ATV Pre Emphasis Filter  
Portland State Aerospace Society  
G.N. LeBrasseur  
glennl@twaves.org  
31-Oct-2004

## Abstract

The ATV system used on LV2 uses a preemphasis filter to compensate between transmitter and receiver frequency response. The preemphasis filter design was provided by PC Electronics, however it seems to impair the video signal rather than help it. I will look at the frequency response using the Saber simulator, and discuss its appropriateness.

**Figure 3 - Bode plot of filter output with 50 ohm source**

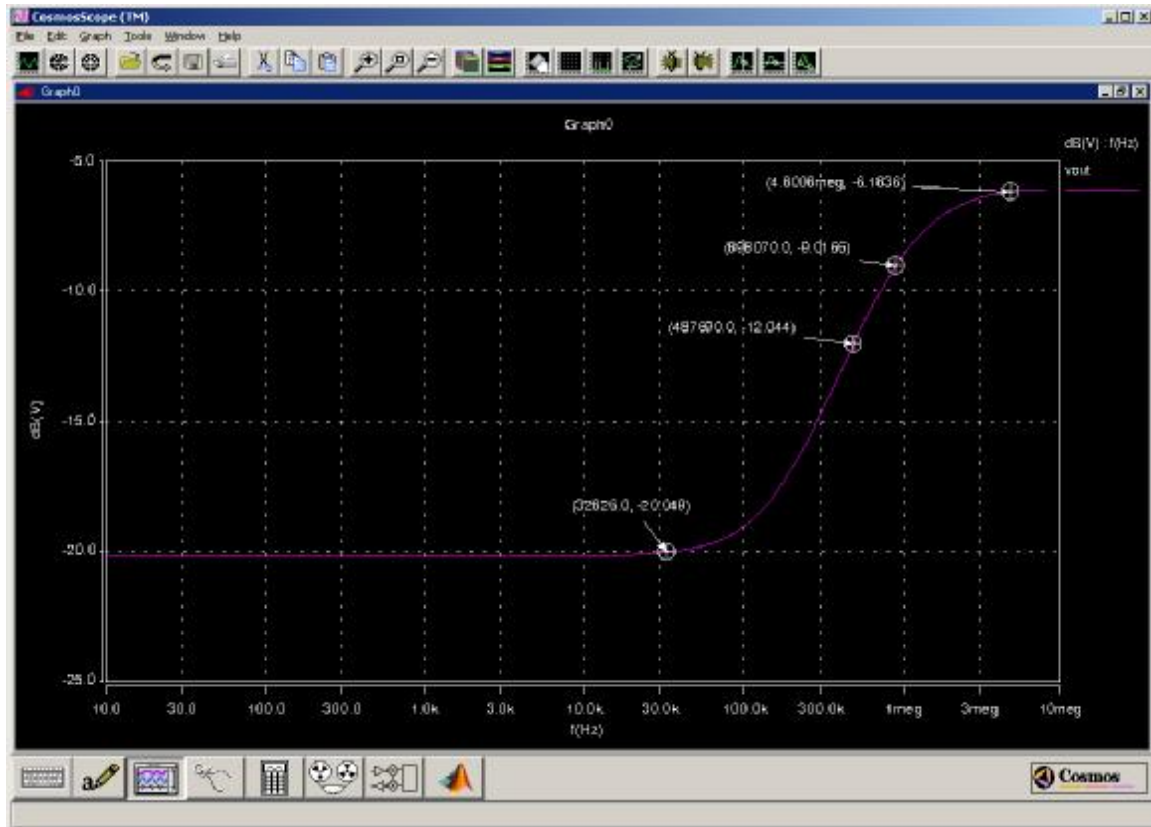
Figure 3 shows the magnitude response of the same filter except it considers the nominal output impedance of the source, which is 50 ohms. Here markers have been placed in the same locations as before. The filter has a 6 dB voltage attenuation on the passband.

This filter introduces a 6 dB attenuation in video signal level. When applied to an FM exciter it will have the effect of reducing the maximum deviation by 50 % (6dB in volts is a half power level, deviation is directly proportional).

It is possible this filter is appropriate, however the video signal level should be amplified by two before the filter, or exciter, or alternately the IF gain of the satellite receiver should be increased. I did discuss satellite receivers used for FM ATV with Tom O'Hara, and he said since ATV signals have less deviation than ordinary C band satellite signals, the IF gain in satellite receivers needs to be increased. These findings are consistent with what he said. However they may be more appropriate as a result of this filters attenuation.
